DART AEROSPACE LTD	Work Order:	94882
Description: Crosstube Assembly (205/212 High Aft)	Part Number:	D212-664-241
Inspection Dwg: D212-664-241 Rev: D		Page 1 of 2

DRAWING NO. REV. D
D212-664-241 SHEET 1 OF 4
TITLE SCALE
CROSSTUBE ASSY (205/212 HI AFT) NTS

DRAWING NO. D212-664-241	TITLE CROSSTUBE ASSY (205/212 HI AFT)	REV. D	DART AEROSPACE LTD ENGINEERING ORDER		D.E.O. NO. D212-664-241-D-1	SHEET NO. SHEET 1 OF 2	SCALE NTS
DRAWN	CHECKED	MFG. APPR.	APPROVED	DE APPR.			
DATE 11.04.07	DATE 11.04.11	DATE 11.04.12	DATE 11/04/12	DATE 11.04.12

DRAWING NO. D212-664-241	TITLE CROSSTUBE ASS'Y (205/212 HI AFT)	REV. D	DART AEROSPACE LTD ENGINEERING ORDER	D.E.O. NO. D212-664-241-D-2	SHEET NO. SHEET 1 OF 1	SCALE NTS
DRAWN <i>q</i>	CHECKED <i>ASS</i>	MFG. APPR. <i>DS</i>	APPROVED <i>MP</i>	DE APPR. <i>#</i>		
DATE 11.07.15	DATE 11.07.20	DATE 11.07.21	DATE 11.07.21	DATE 11.07.21

**D212-664-241/-241B
ASSEMBLY DETAIL**

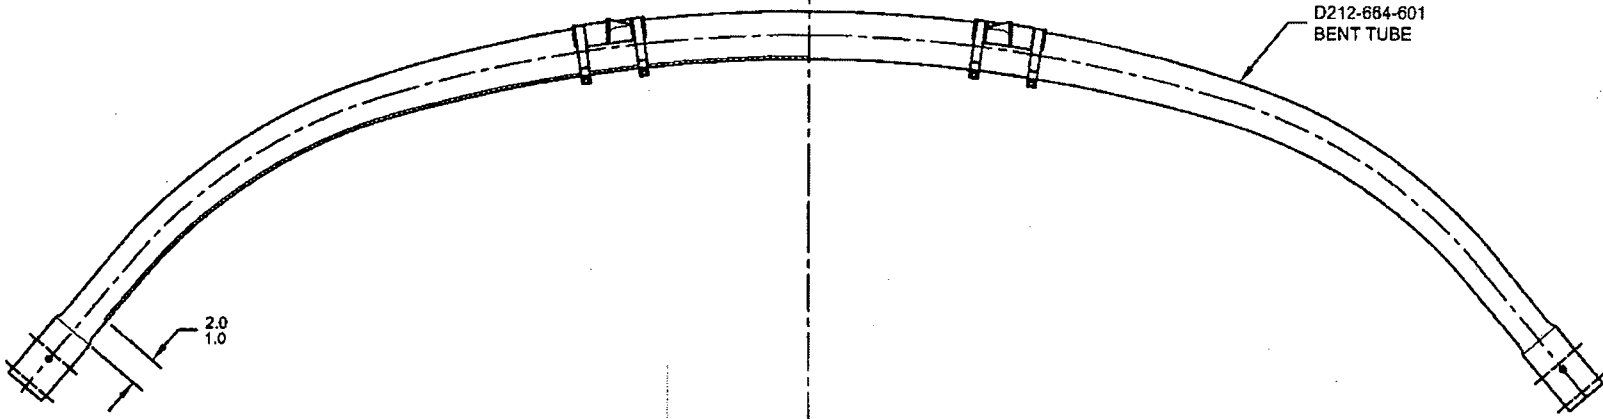
PURPOSE:

ADD AN INSPECTION WINDOW TO UNDERSIDE OF CROSSTUBE.

NOTES 2 OF SHEET 1 IS AMENDED AS FOLLOWS:

- 2) FINISH: CHEMICAL CONVERSION COAT PER DART QSI 005 4.1
PRIME INSIDE AND OUTSIDE PER DART QSI 005 4.2
MASK UNDERSIDE OF CROSSTUBE AS SHOWN (HATCHED AREA) AND
PAINT OUTSIDE PER DART QSI 005 4.2
REMOVE MASKING AND APPLY CLEAR COAT

MASK AREA PRIOR TO PAINTING,
REMOVE MASKING AFTER PAINT
AND APPLY CLEAR COAT
